United States Patent and Trademark Office

APPLICATION NO.	FILING DATE	FIRST NAMED INVENTOR	ATTORNEY DOCKET NO.	CONFIRMATION NO.
10/090,221	03/04/2002	James L. Dunn	P6228	3497
75	590 08/13/2003			
R. Blake Johnston, Esq.			EXAMINER	
P.O. Box 64807			BOGART, MICHAEL G	
Chicago, IL 64	4807		ART UNIT	PAPER NUMBER
			3761	<u></u>
			DATE MAILED: 08/13/2003

DETAILED ACTION

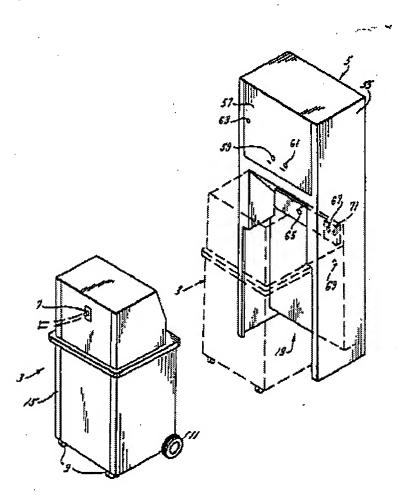
Claims 1, 2 and 9 are rejected under 35 U.S.C. § 102(b) as being anticipated by Parker (US 4,863,446).

Parker teaches a cart (3) for collecting medical waste comprising a body (15) supported by a plurality of wheels (11);

a container (81) supported by said body (15) and having a drain port (53) therein;

a cap positioned on said container (81) and including a patient port (31) and a vacuum port (7) said patient port (31) adapted to selectively communicate with a suction line (33) and said vacuum port (7) adapted to selectively communicate with a vacuum source (fig. 9); and

a liquid level detector (21) in communication with said container (81);

whereby medical waste is collected in said container (81) through a suction line (33) connected to said patient port (31) when said vacuum port (7) is connected to a vacuum source (fig. 9) and the collected medical waste in the container (81) may be detected via the liquid level detector (21)(see fig. 1, below).

Regarding the container cap, the container (81) taught by Parker is designed to operate under a vacuum and inherently has some sort of cap to provide the sealed enclosure necessary to provide such a vacuum.
